Pre-Gateway Review – Planning Proposal at Nos. 366-372 Lane Cove Road, Nos. 124A & 126 Epping Road and No. 1 Paul Street, North Ryde

Amendments to the Preliminary Concept Design

AMENDMENTS TO CONCEPT DESIGN

366-372 LANE COVE RD, 124A & 126 EPPING ROAD &
1 PAUL STREET, NORTH RYDE

FIGURE 1 – REDUCTION IN HEIGHT, BULK AND SCALE

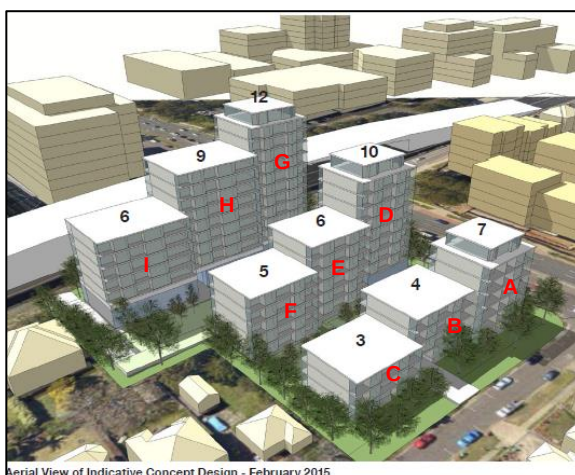
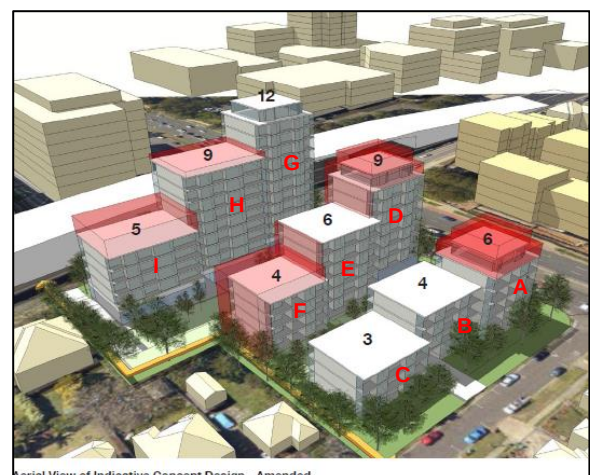
- The height of Building A has been reduced from six storeys to five storeys to improve the transition to the south.
- The height of Building D has been reduced from ten storeys to nine storeys to improve the transition to the south.

- The height of Building F has been reduced from five storeys to four storeys to improve the transition to the west.
- The Height of Building H has been reduced as result of lowering the floor to ceiling height of the commercial tenancy on the ground floor.

- The height of the Building I has been reduced from six storeys to five storeys to improve the transition to the west.
- The western setback of the central built form has been increased from 3m to 6.5m to improve the relationship to residential development to the west.

- As a result of the reduction in height and increased setbacks the FSR has been reduced from 2.5:1 to 2.24:1.
- The residential GFA has been reduced from 15,539m² to 13,500m², resulting in a reduction in apartments from 180 to 156. The amendments maintain a mixture of dwelling types to contribute to housing variety and affordability. Further, the reduction in dwellings will reduce any potential traffic impacts.

Figure 6: Concept plan. Source: BatesSmart Preliminary Concept Design 2015

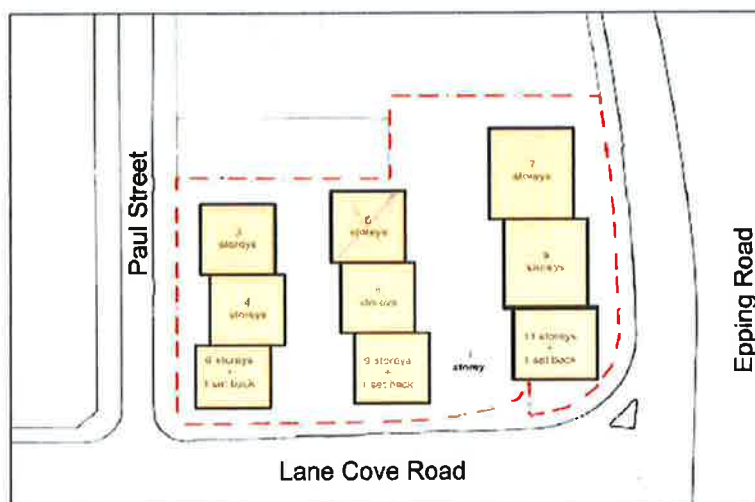
However the Department does not support the proposed height and FSR by the proponent as the proposal's interface (three to seven storeys) with the adjacent low density residential area is not as sensitive as the nearby three storey Part 3A developments approved in the vicinity.

The Department recommends the Panel considers the recommendations of the approved Part 3A developments in the vicinity when defining the maximum building height and FSR for the site particularly where it adjoins the single storey dwellings. Reducing the proposed building height and FSR would provide a more appropriate interface and transition from the single storey residential development to the west and south of the site to the zoned B3 Commercial Core to the north, whilst maintaining the amenity of the existing low residential density area south of Epping Road.

Aerial View of Indicative Concept Design - Amended

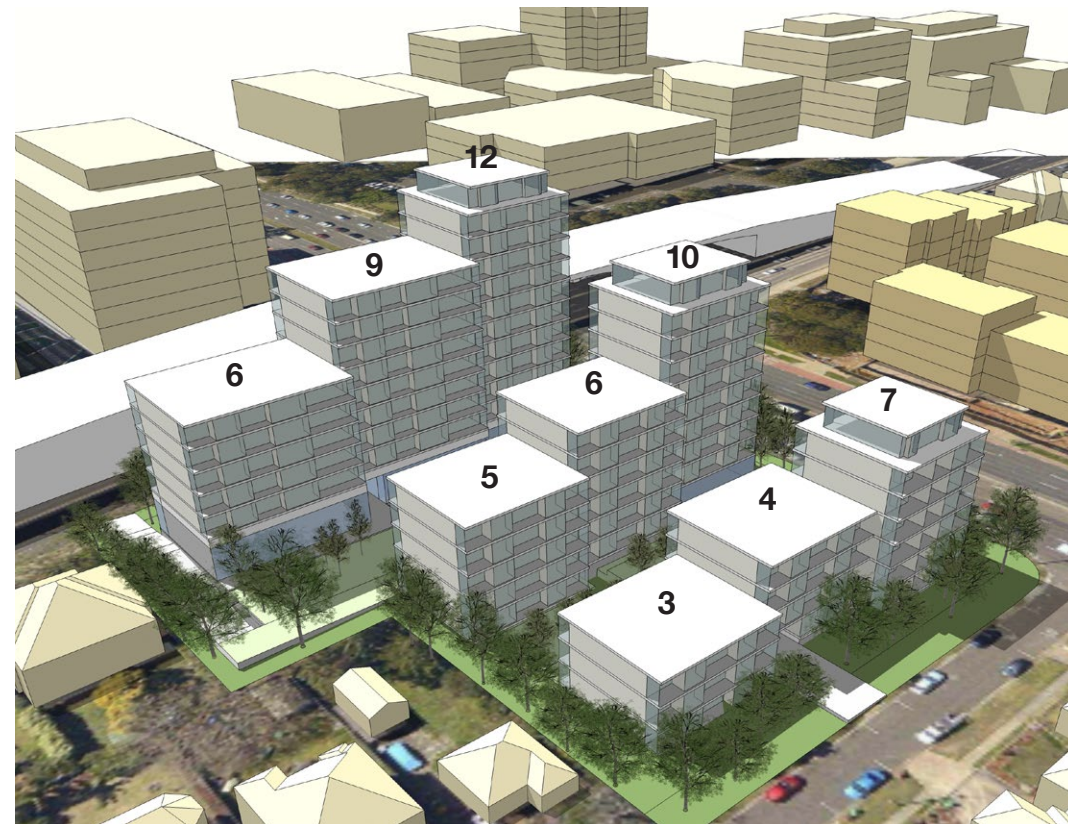
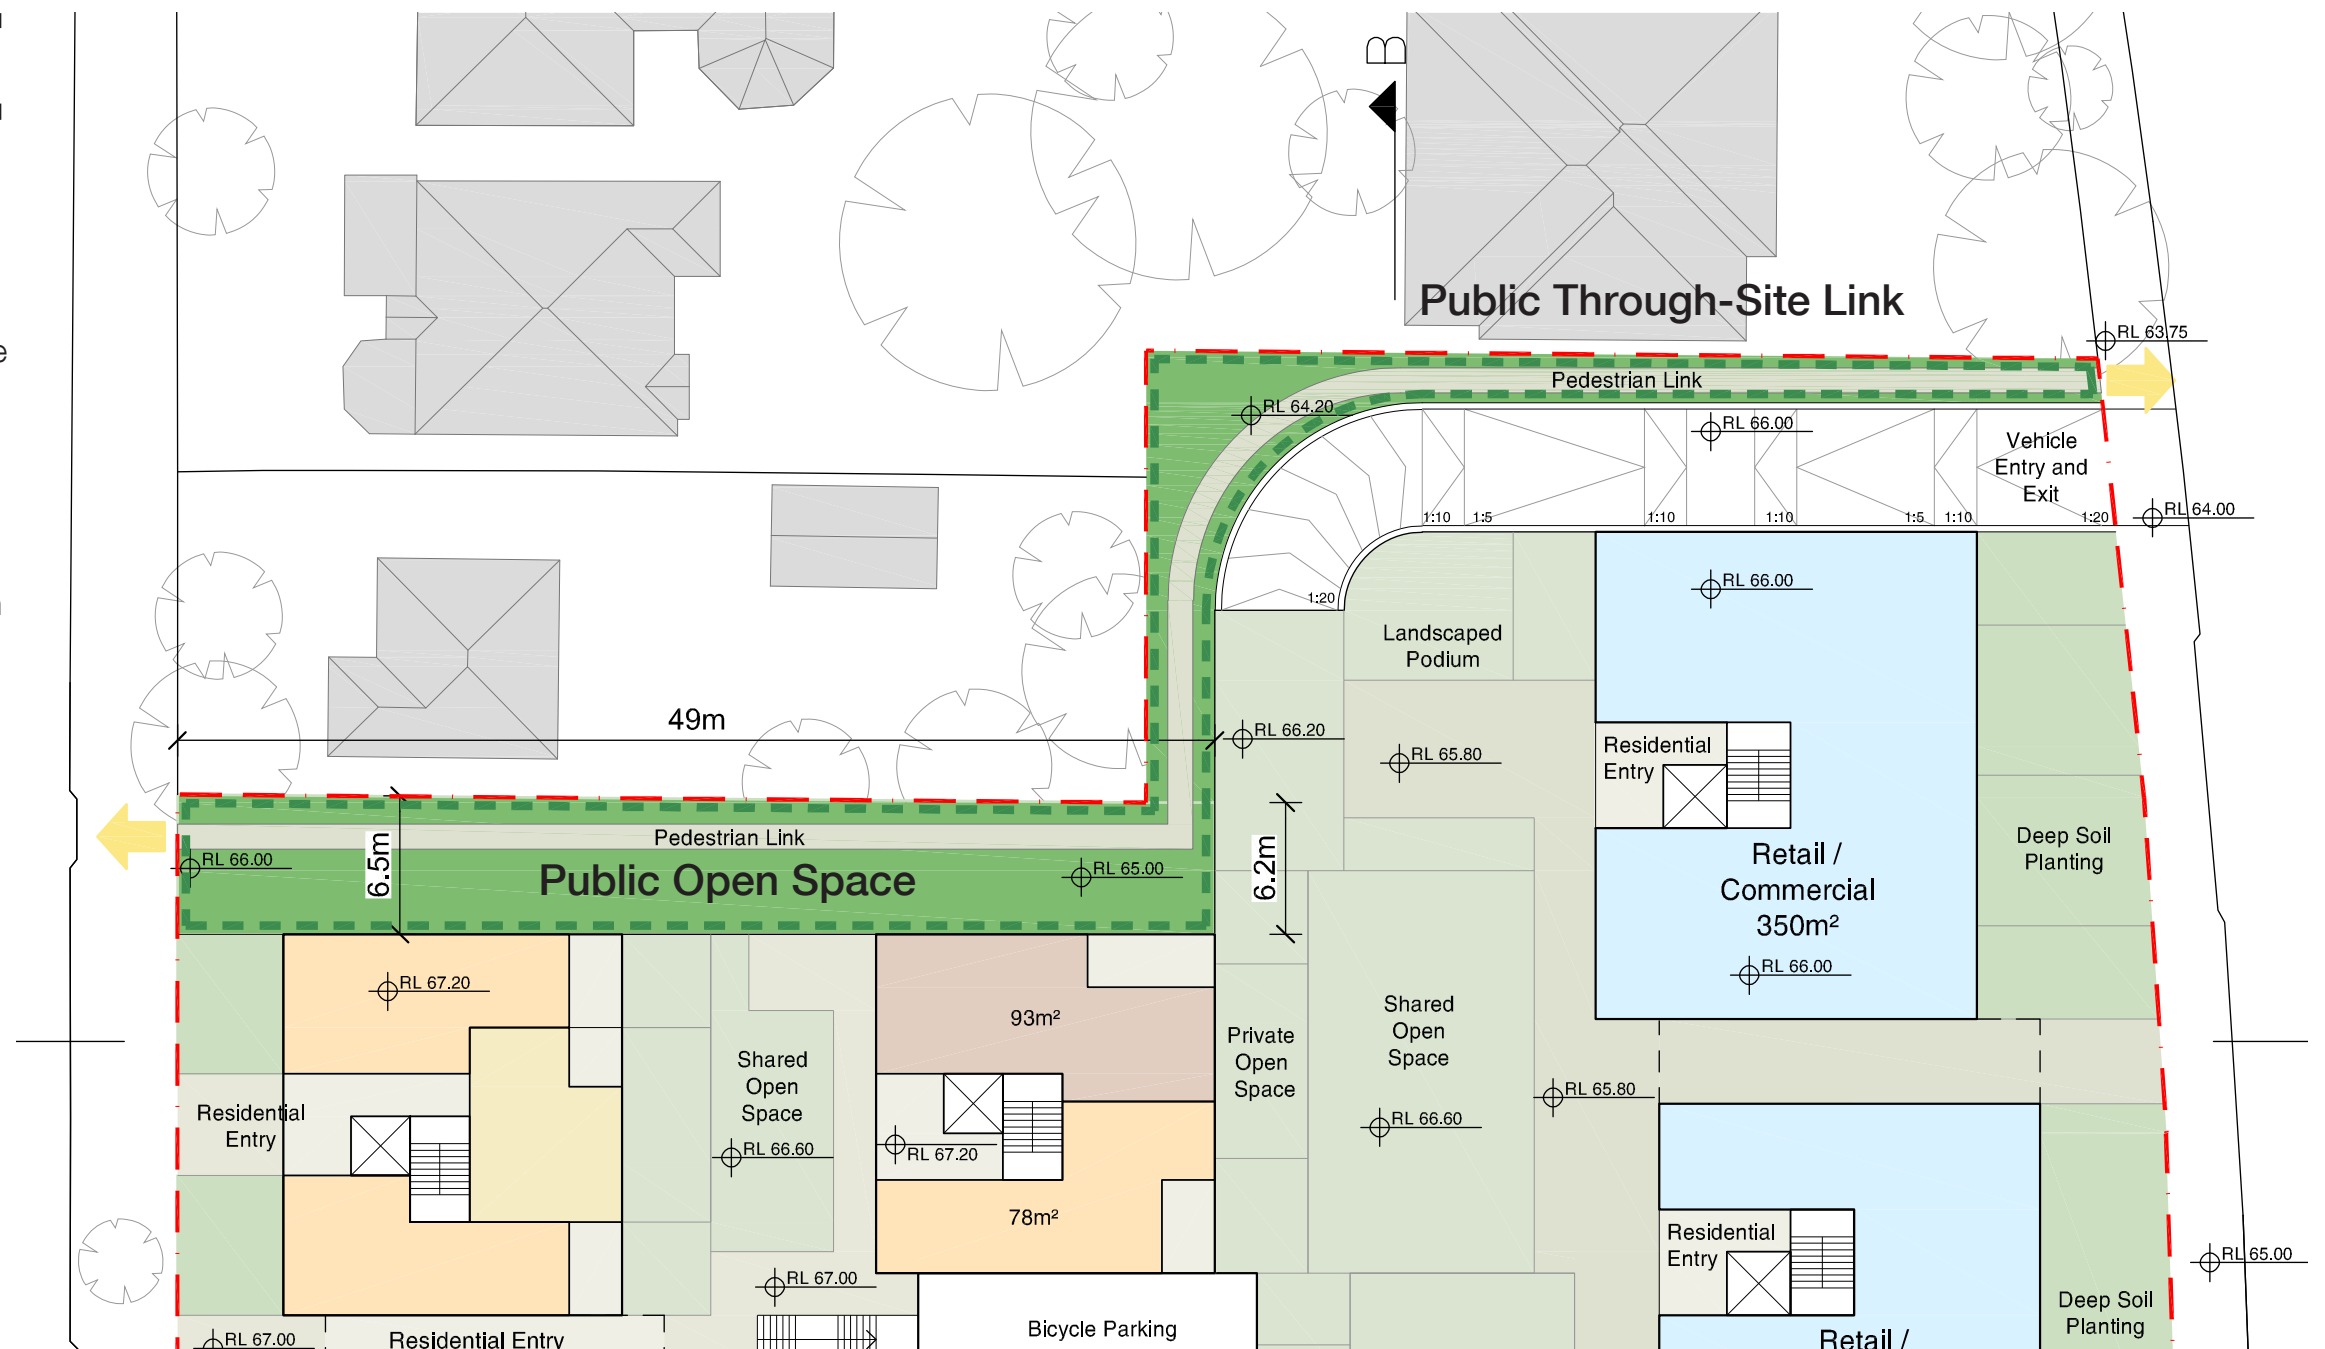
- / The five and seven storey building envelopes at the northern boundary of the site have been reduced by one storey in height
- / The seven and ten storey building envelopes at the fronting Lane Cove Road have been reduced by one storey in height
- / Public open space and a through-site link have been created within the site, and the building setbacks to the north increased to allow this
- / The ground floor apartments at the northern corner of the site have been changed to retail/commercial uses
- / The floor-to-floor height of the retail/commercial tenancies fronting Epping Road has been reduced from 6 metres to 4.5 metres
